## ADDENDUM NO. 2

CITY OF WILLCOX  
WASTEWATER TREATMENT PLANT  
SINGLE LINE DIAGRAM 1 OF 2  
ELE-MCC-005

CITY OF WILCOX  
WASTEWATER TREATMENT PLANT  
ELECTRICAL PLAN - BLOWER/ELECTRICAL BUILDING  
WILSON PROJECT NO. 11004

Sheet No. E-2.0

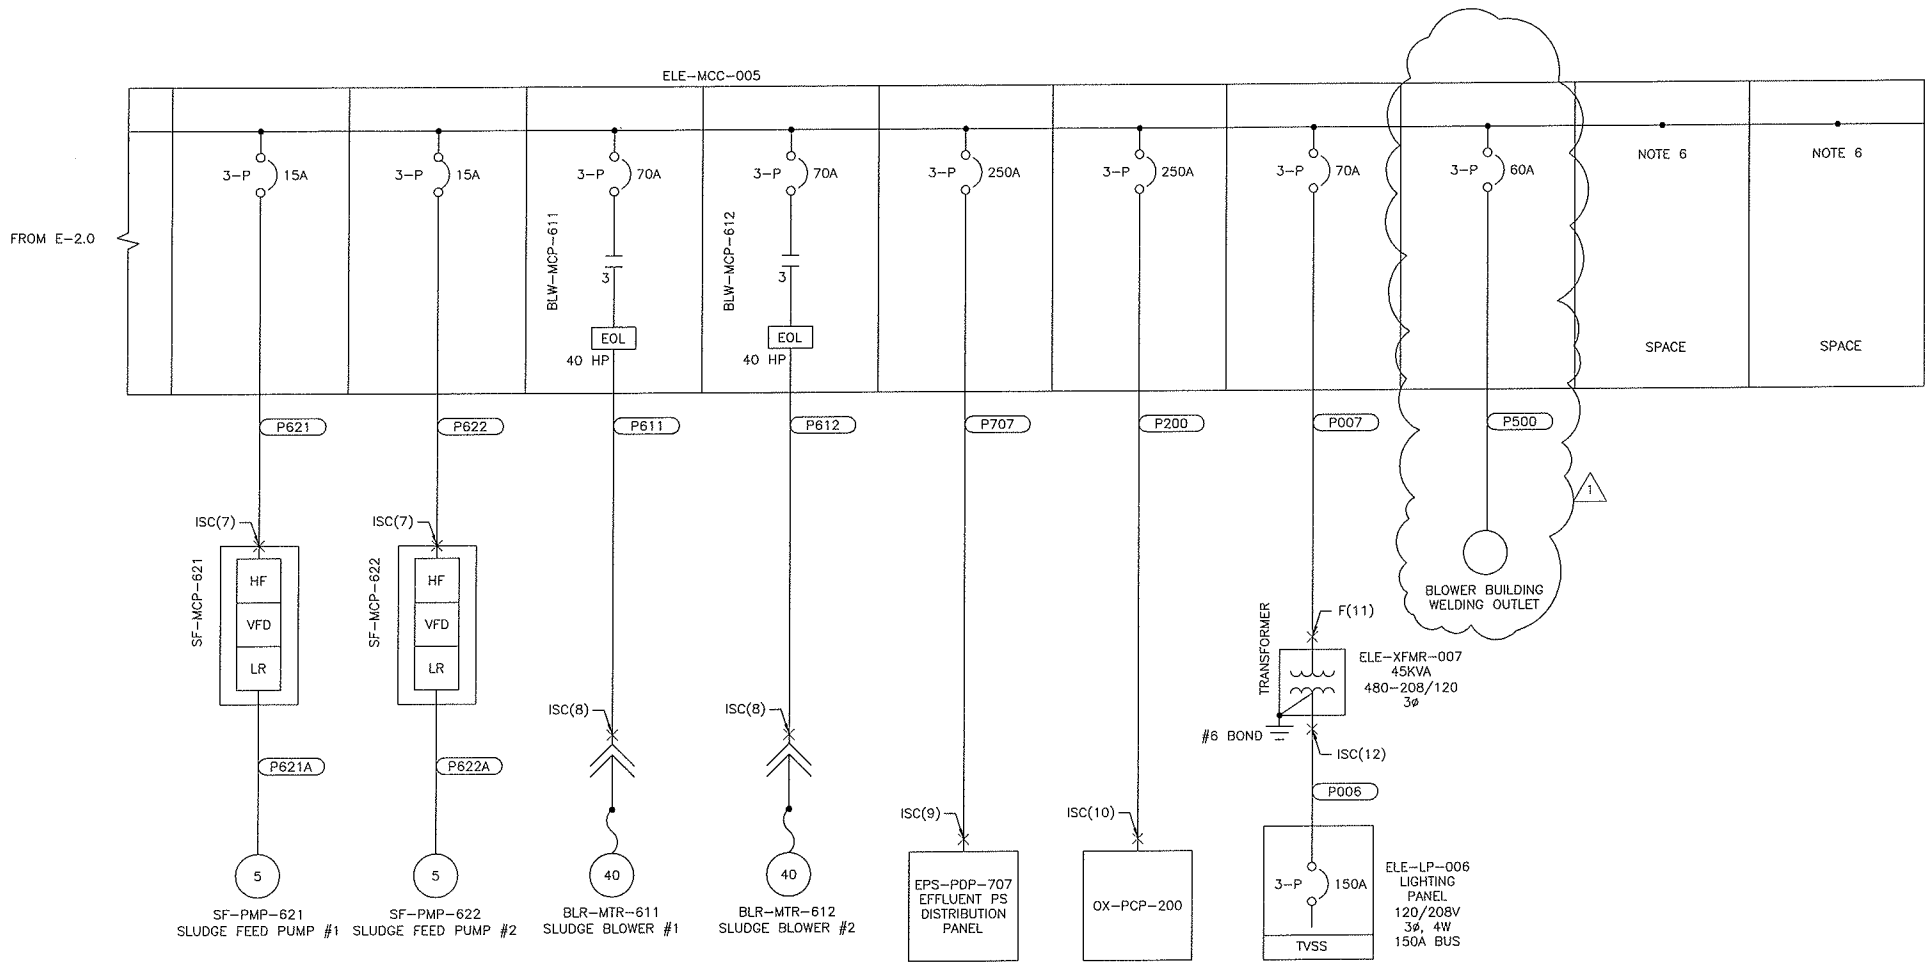
5. **Question:** Sheet E-3.3 shows a welding outlet with the note ELE-LP-006 Ckt#14. Sheet E2.3 panel schedule ELE-LP-006 shows circuit #14 to be for the AC Unit #2. What size breaker is required for the welding outlet, and what size conduit and wire are required?

1. E-2.0 – SINGLE LINE DIAGRAM 1 OF 2 ELE-MCC-005
  - a. **REPLACE** Drawing E-2.0 with Revised Drawing E-2.0.
  - b. On Drawing E-2.0, Blower Building Welding outlet added to the Load Summary.
2. E-2.1 – SINGLE LINE DIAGRAM 2 OF 2 ELE-MCC-005
  - a. **REPLACE** Drawing E-2.1 with Revised Drawing E-2.1.
  - b. On Drawing E-2.0, Blower Building Welding outlet added to ELE-MCC-005.
3. E-2.3 – 120/208V PANEL SCHEDULES SHEET 1 OF 2
  - a. **REPLACE** Drawing E-2.3 with Revised Drawing E-2.3.
  - b. On Drawing E-2.3, Panel RAS-LP-309, Circuit 16, **ADD** "WAS-AIT-335", "0.9Amps" load.

**Response:** Welding outlet is powered from ELE-MCC-005. E-2.0 & E-2.1 revised.

Sheet No. E-3.6

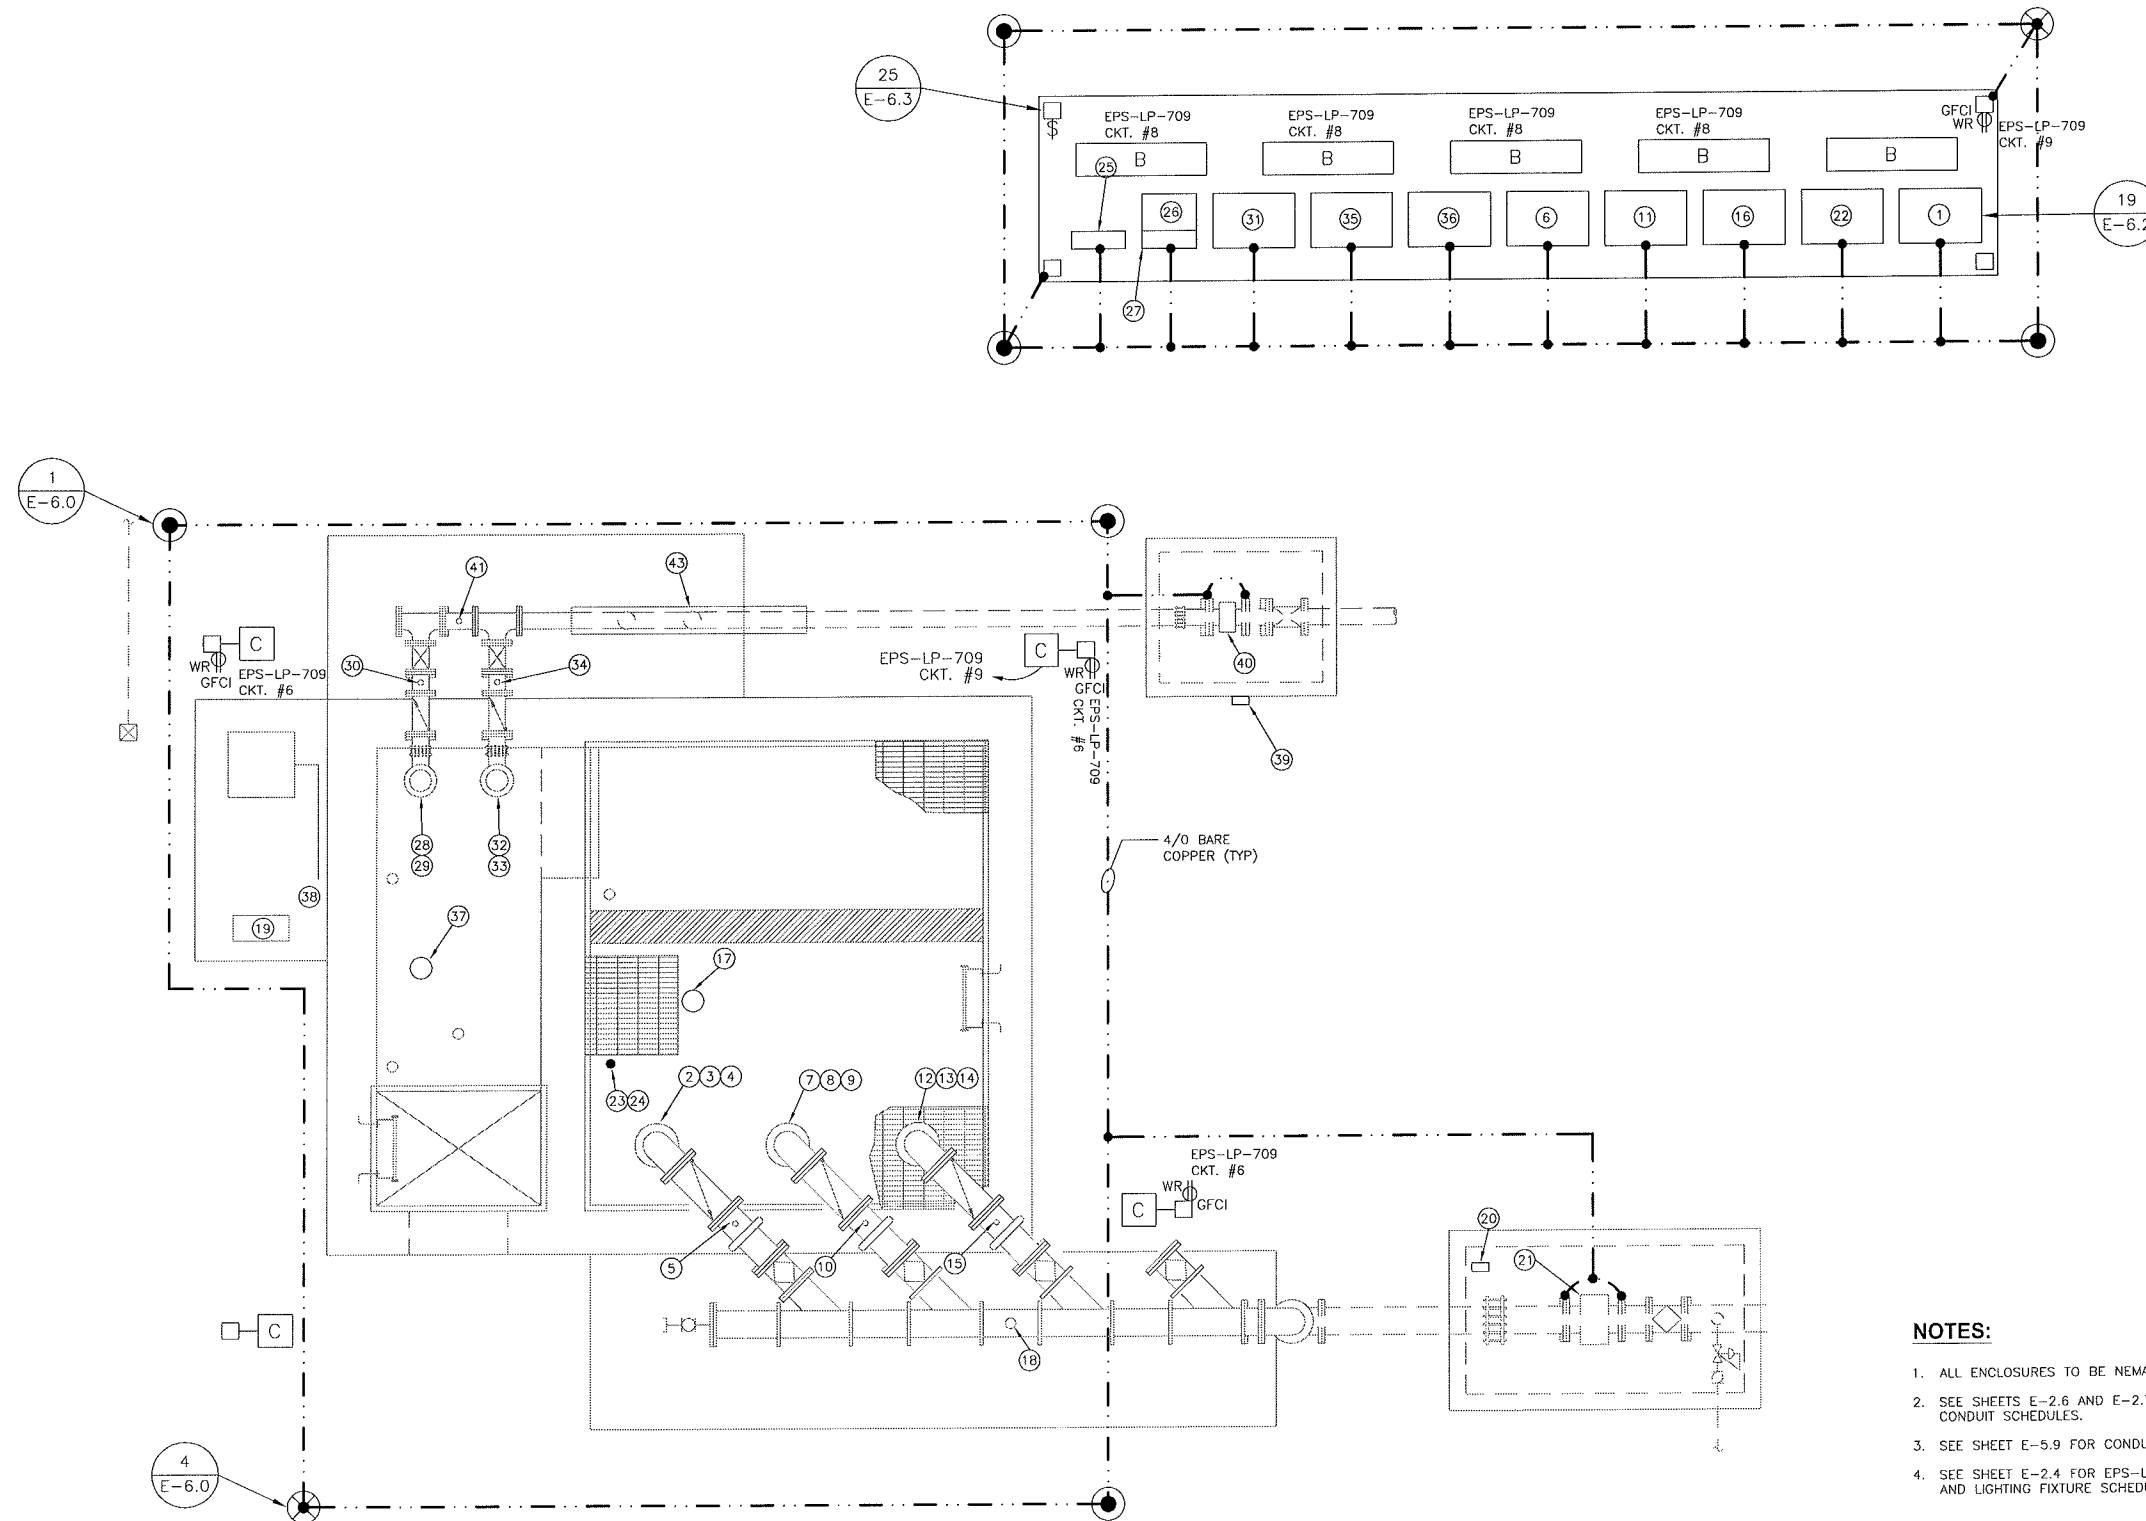
2. **Question:** Sheet E-3.6, keynotes 5 and 6, are for SPS-LIT-343 and SPS-LIT-344. These two instruments are not shown in the P&ID or the Conduit Block Diagram. Are these instruments to be included in this project? If yes, please revised the P&ID, Conduit Block Diagram and Conduit schedule to show the instruments.

**7. E-3.6 – ELECTRICAL PLAN – SECONDARY CLARIFIERS**

**Response:** See DRAWINGS: Item 7 below. SPS-LIT-343 and SPS-LIT-344 show up on P&ID I-2.5A and are labeled SPS-LIT-341 and SPS-LIT-342.

- a. **REPLACE** Drawing E-3.6 with Revised Drawing E-3.6.
- b. Keyed Notes, #5, **REVISED** "SPS-LIT-343" to read "SPS-LIT-341".
- c. Keyed Notes, #6, **REVISED** "SPS-LIT-344" to read "SPS-LIT-342".

Sheet No. E-5.1

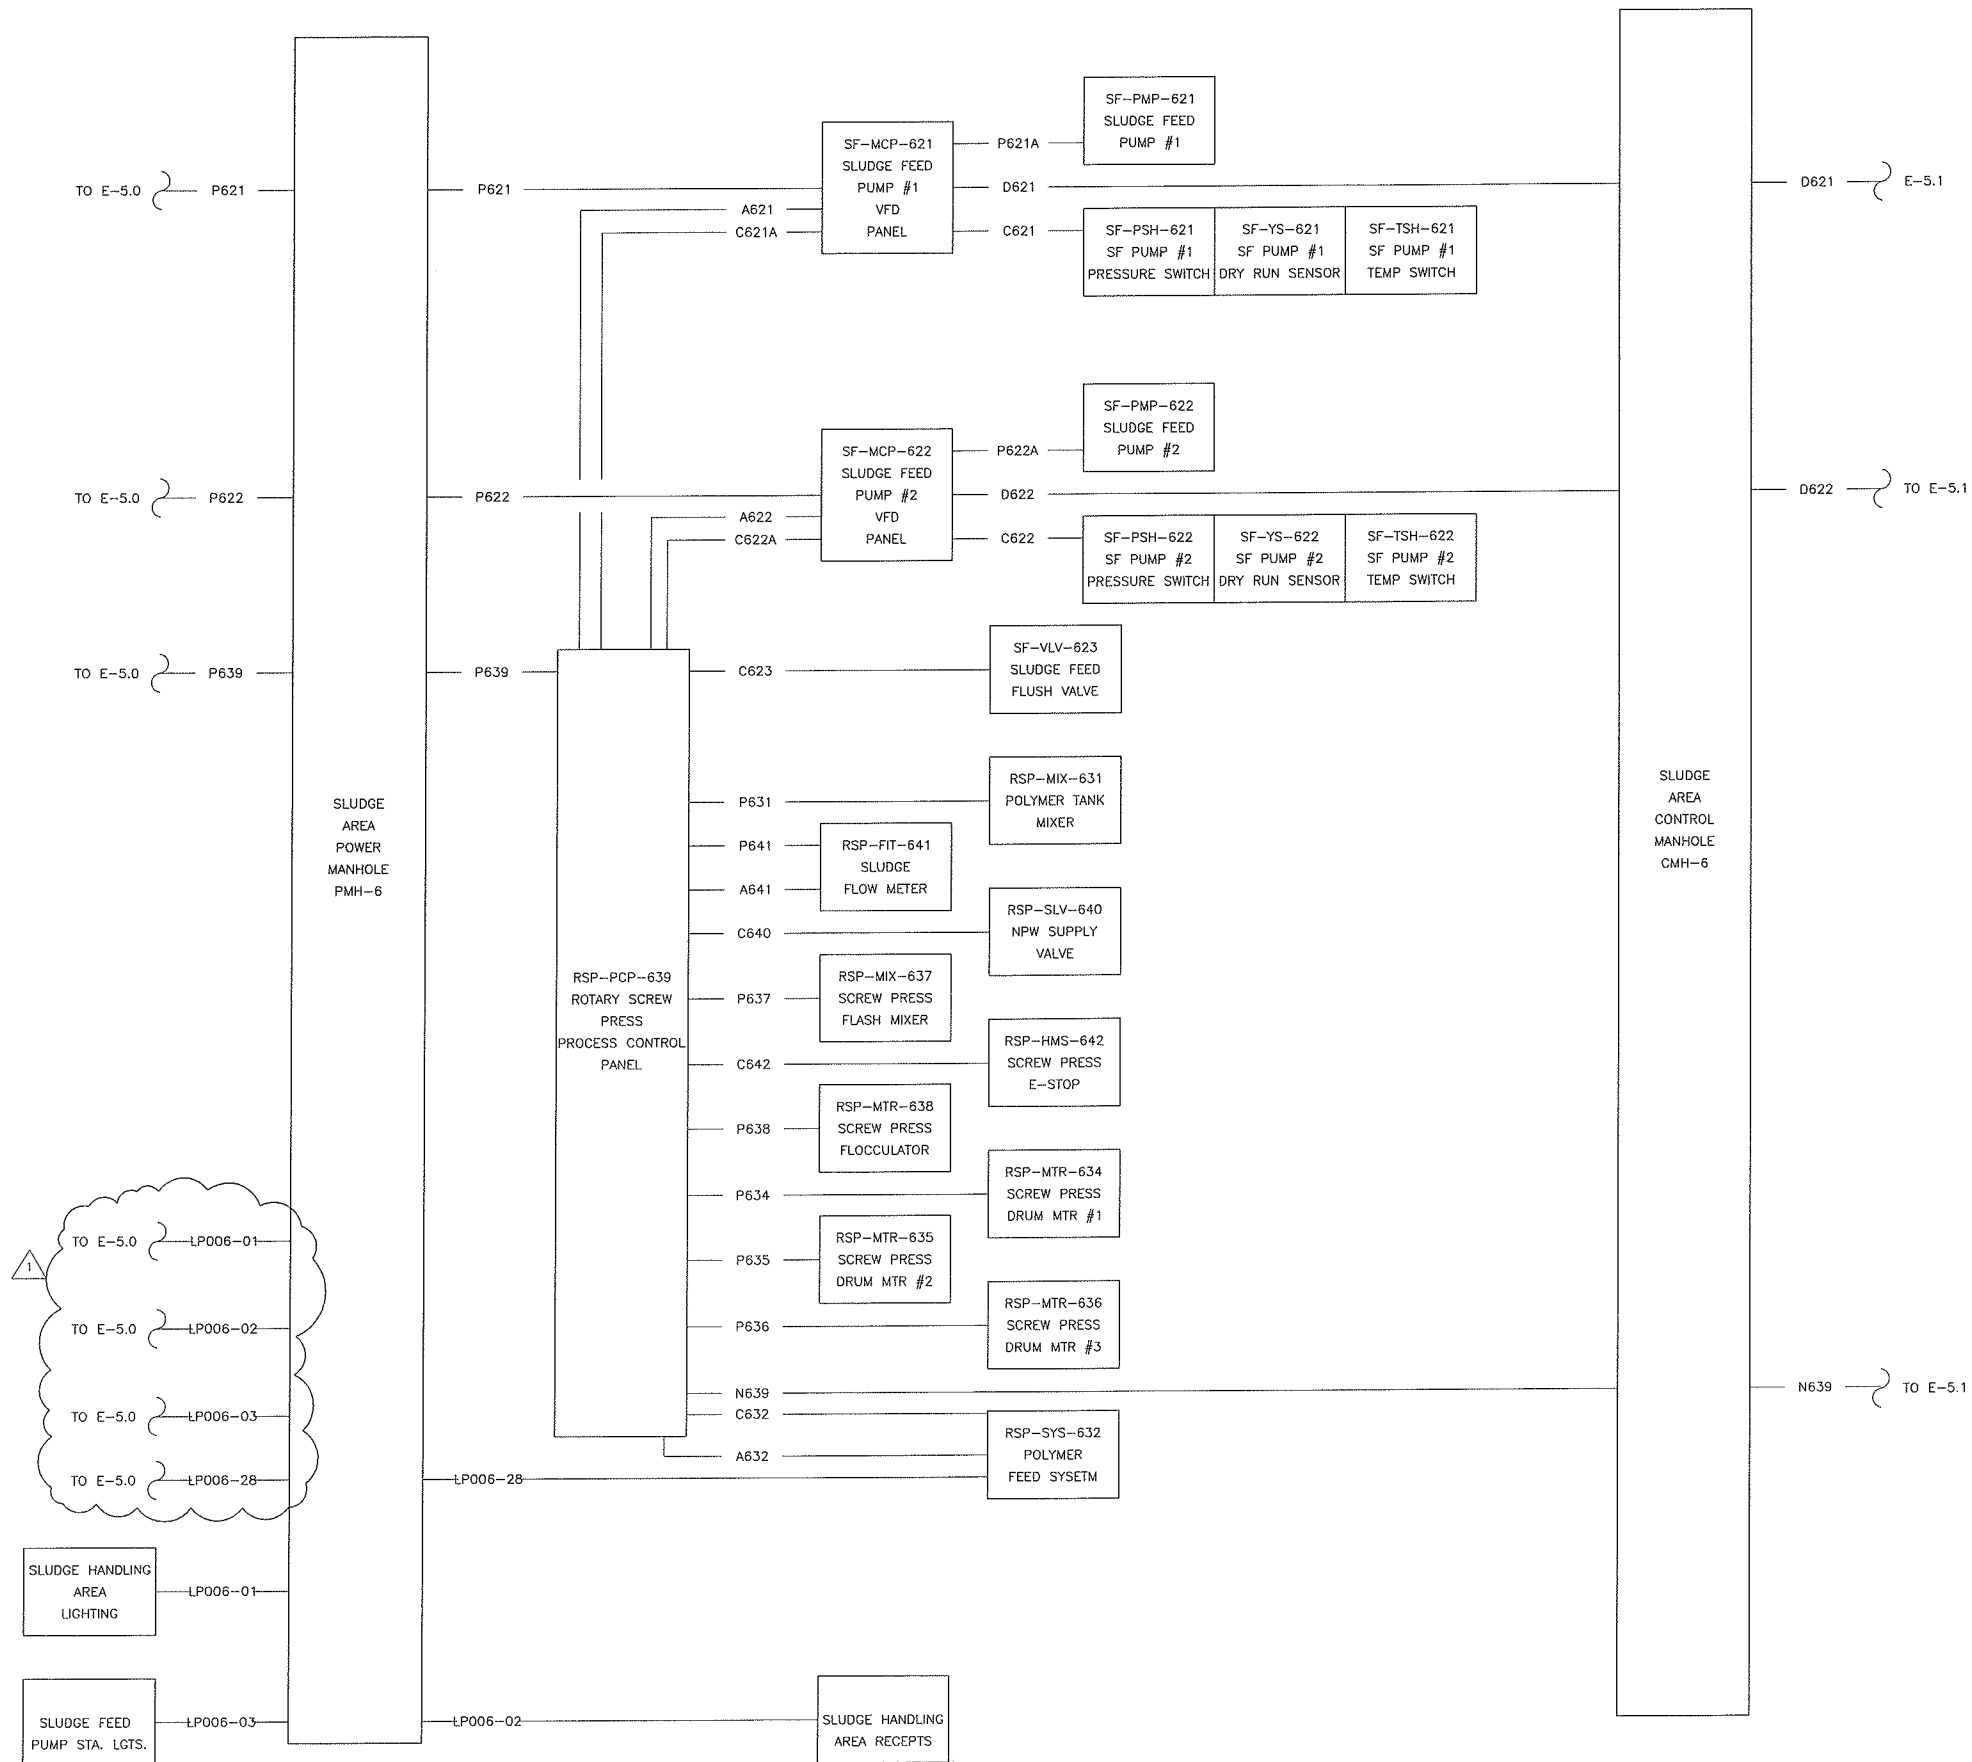
18. **Question:** Sheets E-3.9 and I-2.9 show LCP-610 and LIT-610. The LCP and LIT are not shown in the conduit block diagram. Please provide the conduit number with the conduit size and wires required for the connection between ELE-PLC-010 to SHT-LCP-610 to LIT-610.

**Response:** See drawing E-5.1, Conduit Block Diagram Control General & Sludge/Blower for LCP-610 and LIT-610.

- a. **REPLACE** Drawing E-5.1 with Revised Drawing E-5.1.
- b. **ADDED** Conduit "P500" between ELE-MCC-005 and the Welding Receptacle.
